EFNA Steering Committee

Meeting Summary

Lacy Road

Fitchburg Community Center to S. Syene Road

DESIRABLE TERRACE FOR RUNNING LENGTH

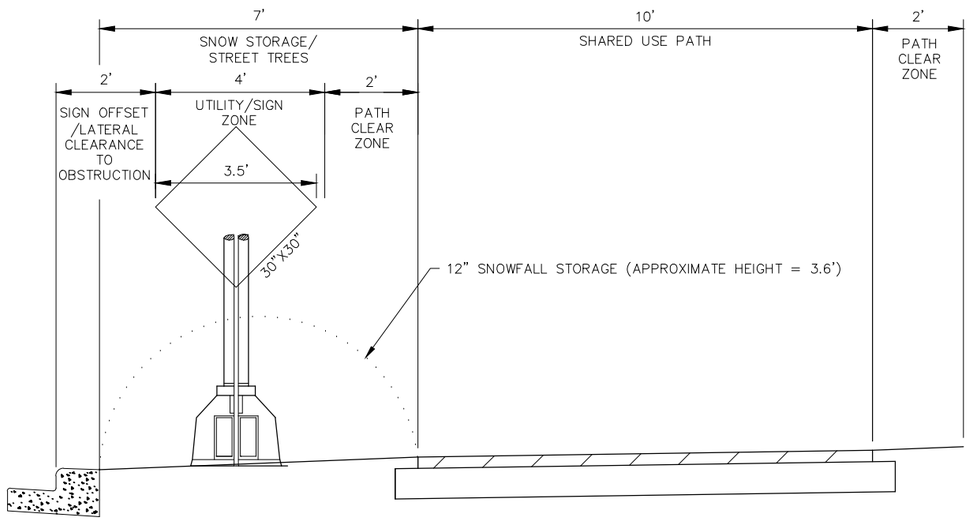
1. Minimum terrace width discussion
    a. Troy Pankratz, Mead & Hunt, described the desirable terrace width for running length along Lacy Road to be a minimum of 7.0'. The terrace provides multiple functions which are critical for maintenance and storage. The terrace provides the following benefits:

i. Clearances for both the path (2' minimum to a sign edge) and road (2' offset from face of curb to edge of sign)
        ii. Snow storage –Troy explained that the snow pile height would reach 3.6' within the 7' terrace from clearing one 12" snowfall. This is based on the road-only. It did not include the shared-use path. However, the path will also need to be cleared into the terrace where it is in a cut section, or if retaining walls are constructed to minimize the grading work.
        iii. Placement of street signs – the maximum size that would be needed on this project would be a 30"x30" diamond sign, resulting in a 3.5' width of sign.
        iv. Placement of street lights – Ahna commented that although the street lights have not yet been determined for the project, the plan would be to alternate street lights on both sides of the road. She commented that street lights would need to be replaced, at very minimum, to replace the overhead lights that may come down with the burying of overhead electric lines.

v. Utilities – Ahna commented that she had met with MG&E to begin the discussion of burying the overhead electric lines. Should the City proceed with burying the lines, the preliminary concept is to bury the lines in the terrace on the south side of Lacy Road. The terrace provides a location for the underground utilities including electric and the existing sanitary sewer. By locating these utilities in the terrace, it minimizes the disruption of the road and path during maintenance activities.
        vi. Driveway Aprons – The path will need to maintain a 1.5% cross-slope. The driveways need space to meet the road elevation. Without an adequate terrace width, the driveway aprons will be very steep, causing issues with access into or out of the driveways.
        vii. Placement of refuse and recycling bins – Local ordinances prohibit the placement of refuse and recycling containers in the roadway. They will either need to be placed in the driveway apron or in the terrace.

MINIMUM TERRACE AT ISOLATED LOCATIONS

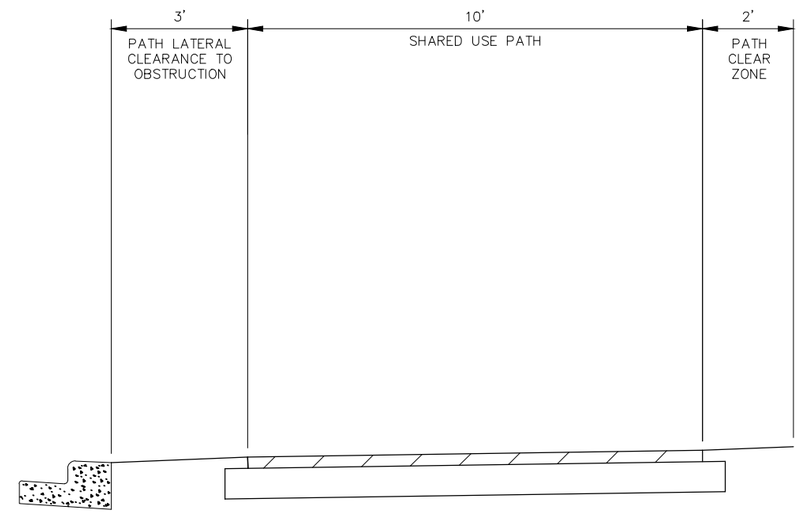
b. At isolated locations, the terrace can be reduced down to a minimum width of 3'. This would be for a short length to avoid a tree, environmental impacts (wetlands), or at pinch points where existing terrain requires a narrower section.

PROJECT NO:5849-00-09	HWY:LACY ROAD	COUNTY:DANE	PRELIMINARY IMPACTS	PAGE 1

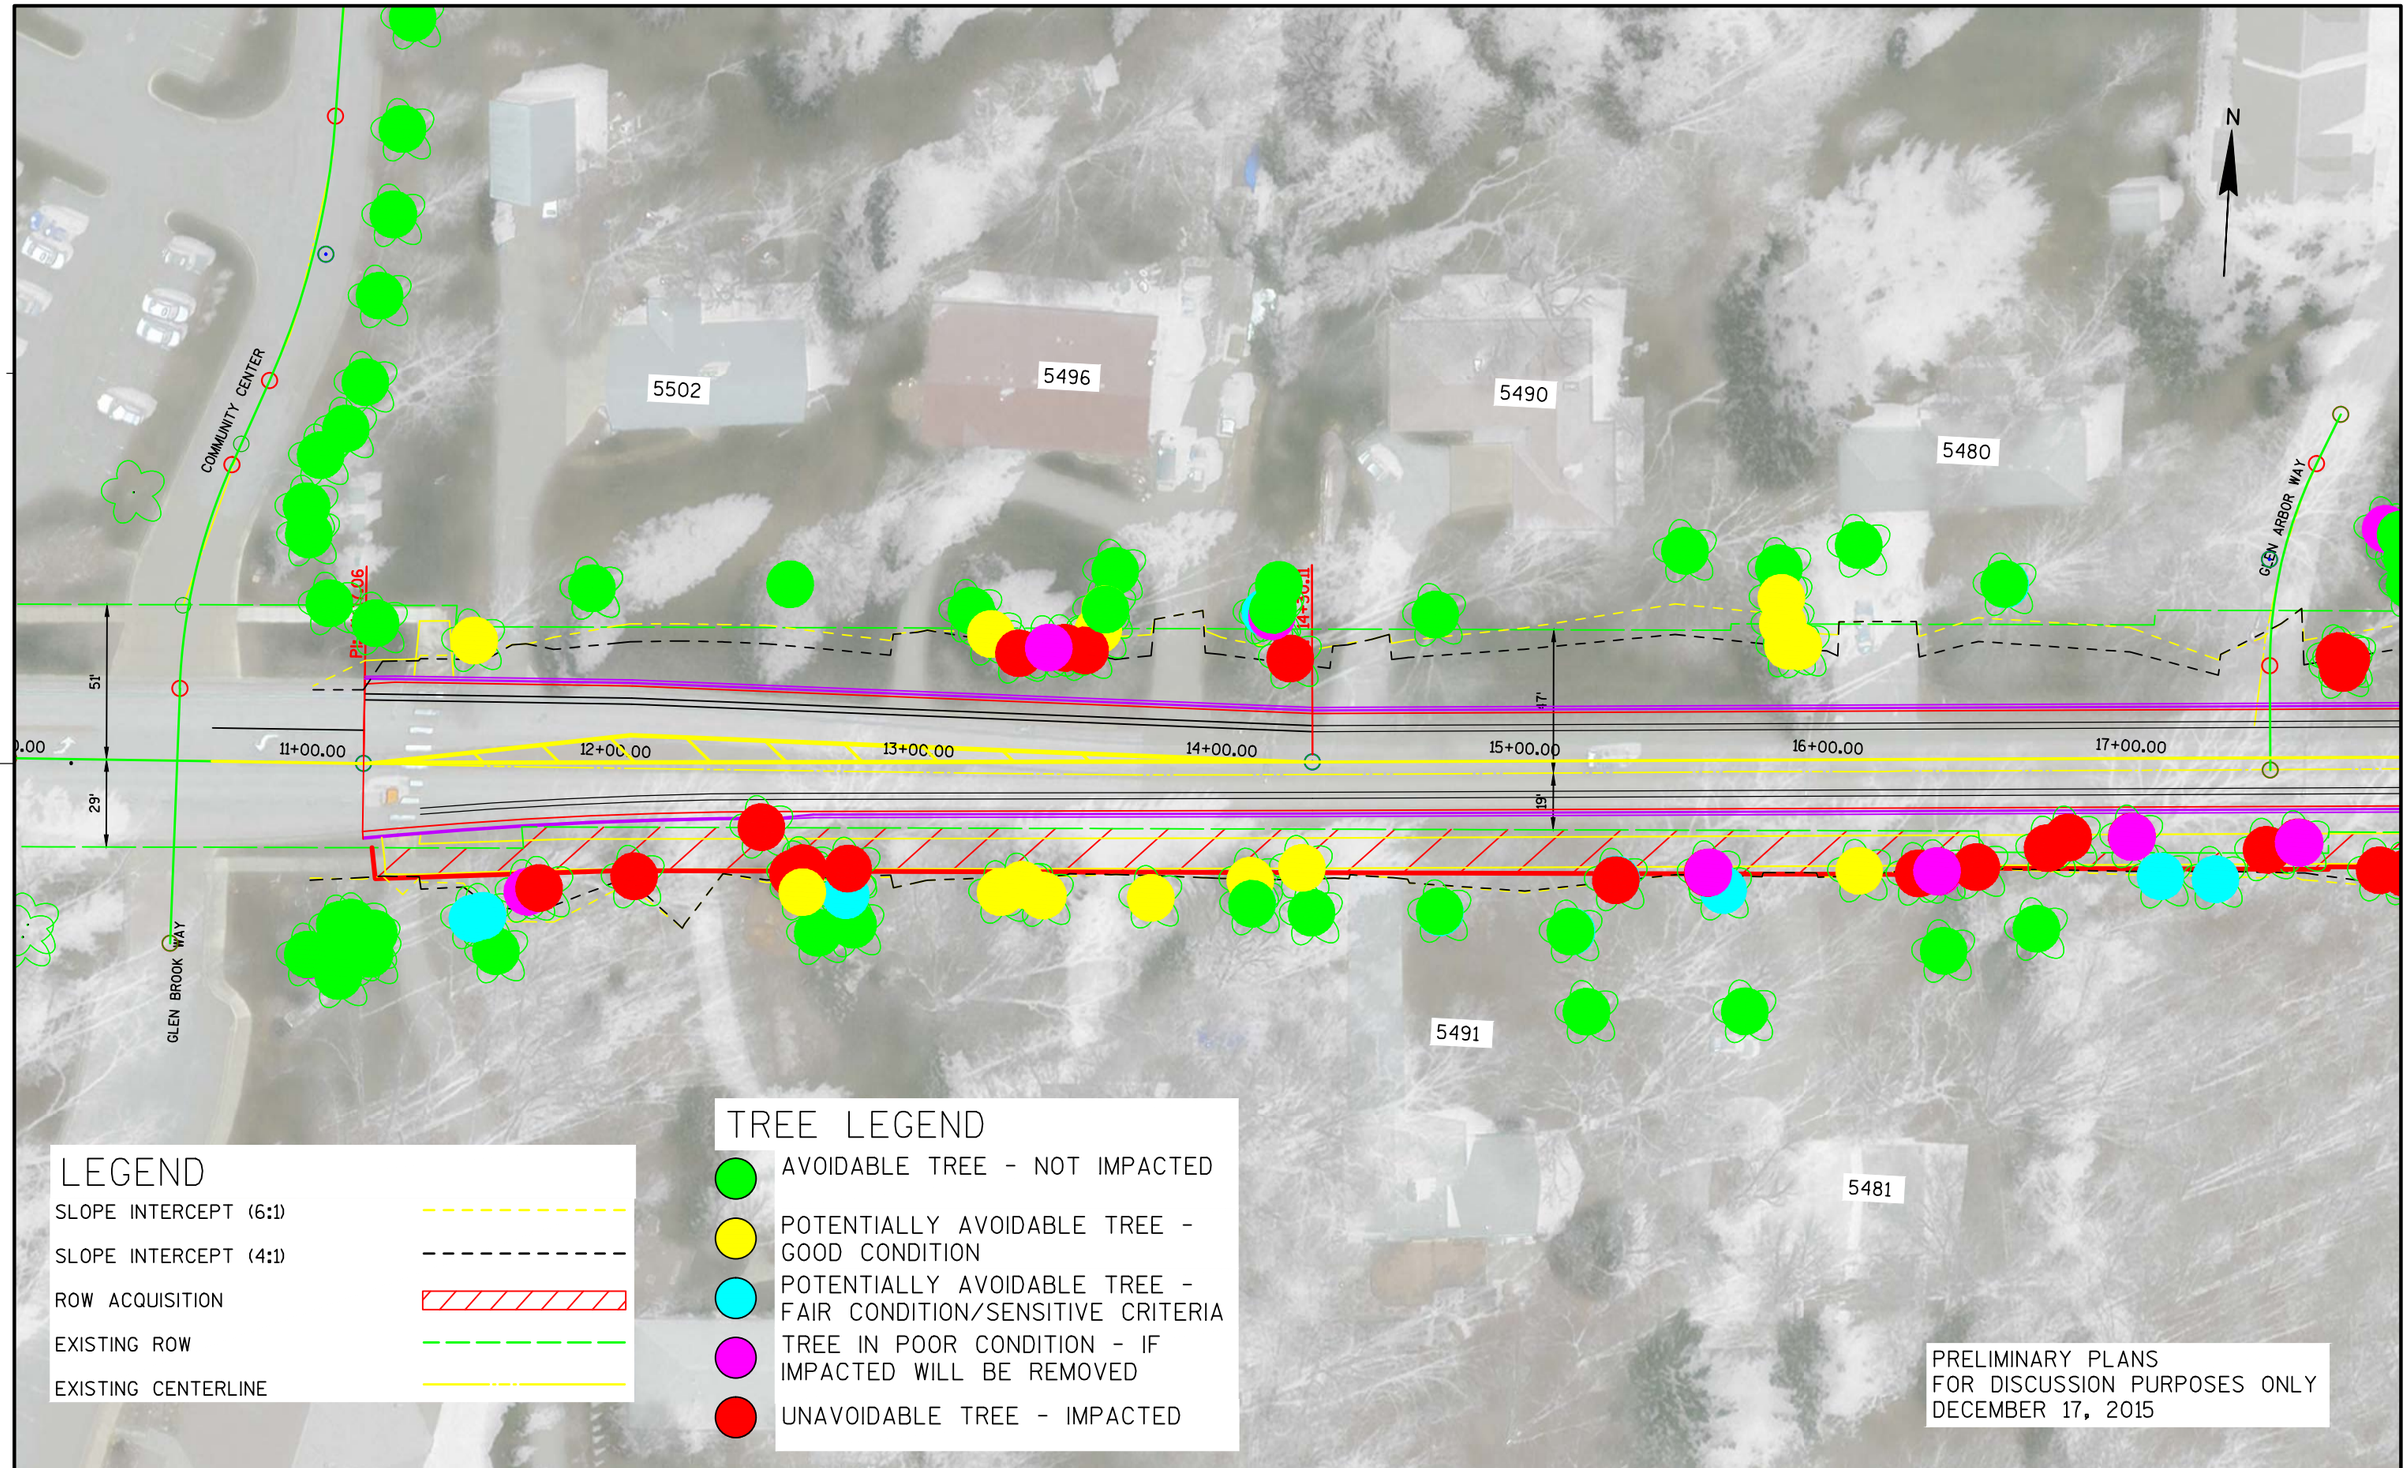
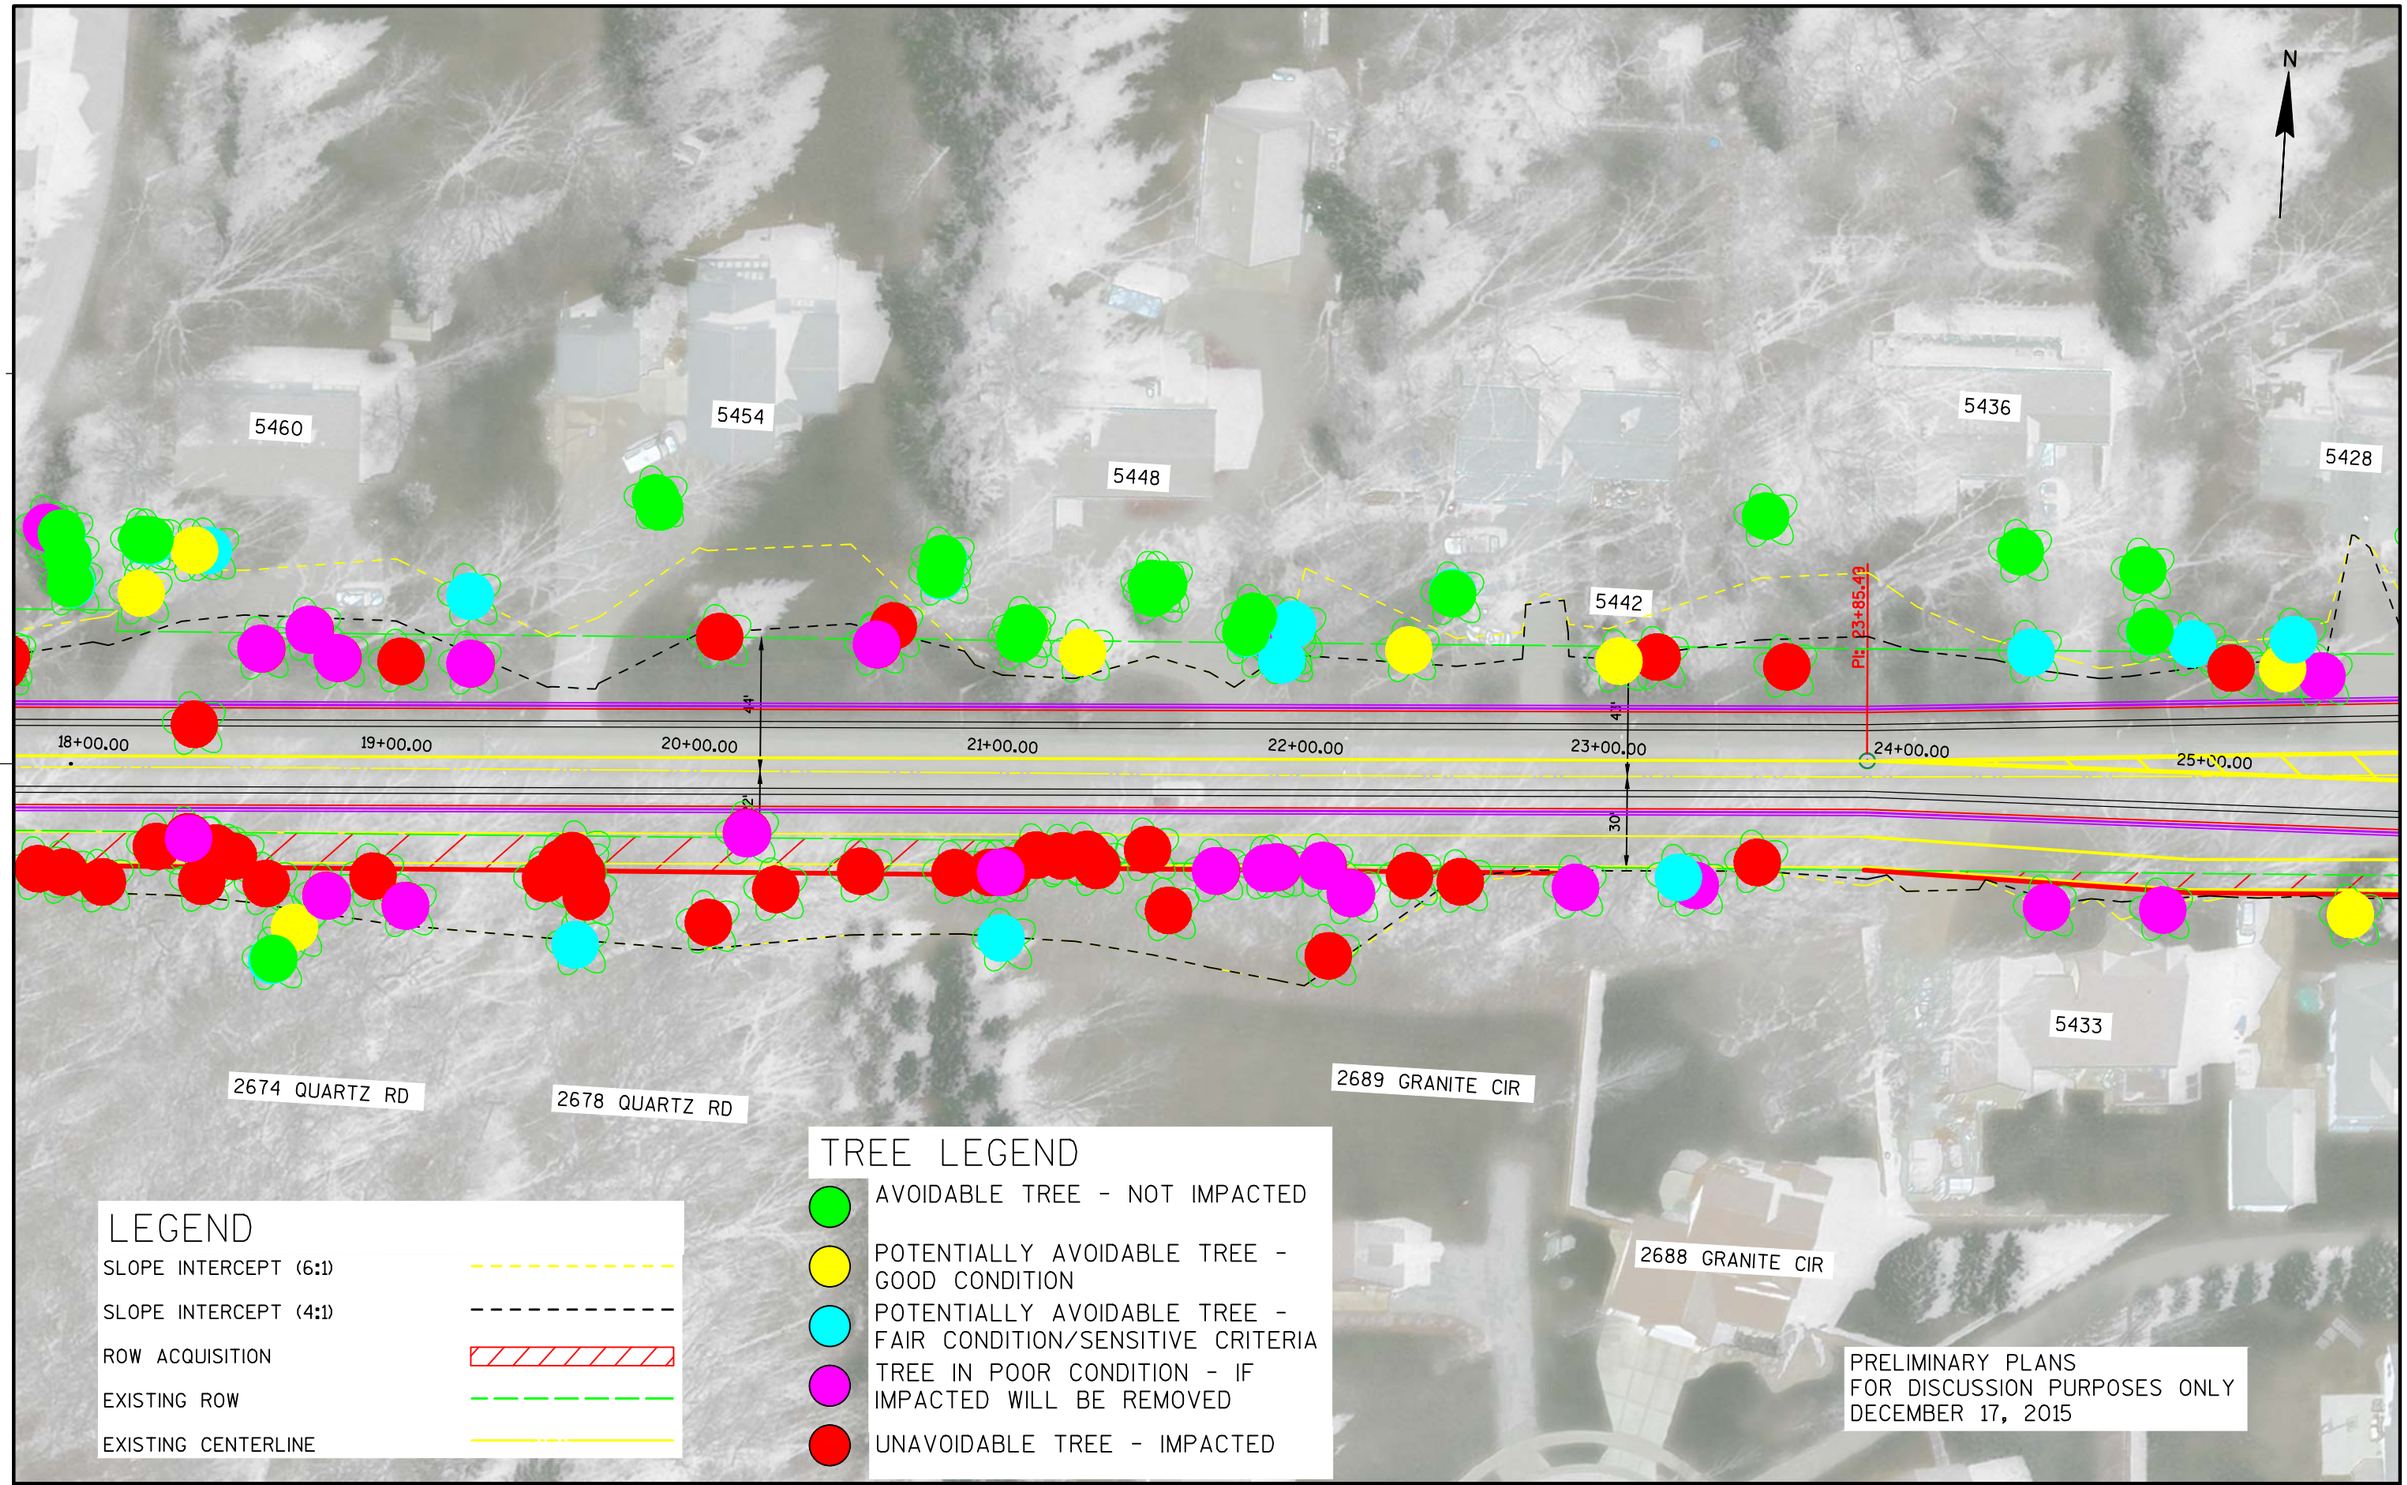
4. Tree evaluation update – Troy provided plans that show each tree along the road. The trees were color-coded to identify "avoidable tree", "potentially avoidable – good condition", "potentially avoidable – fair condition", "potentially avoidable – poor condition", and "unavoidable tree – impacted". These drawings are hot off the press – so additional analysis has not been completed to determine what adjustments would be made to the alignment, terrace width, or path width to potentially avoid tree removals. That is one of the next steps with the design.
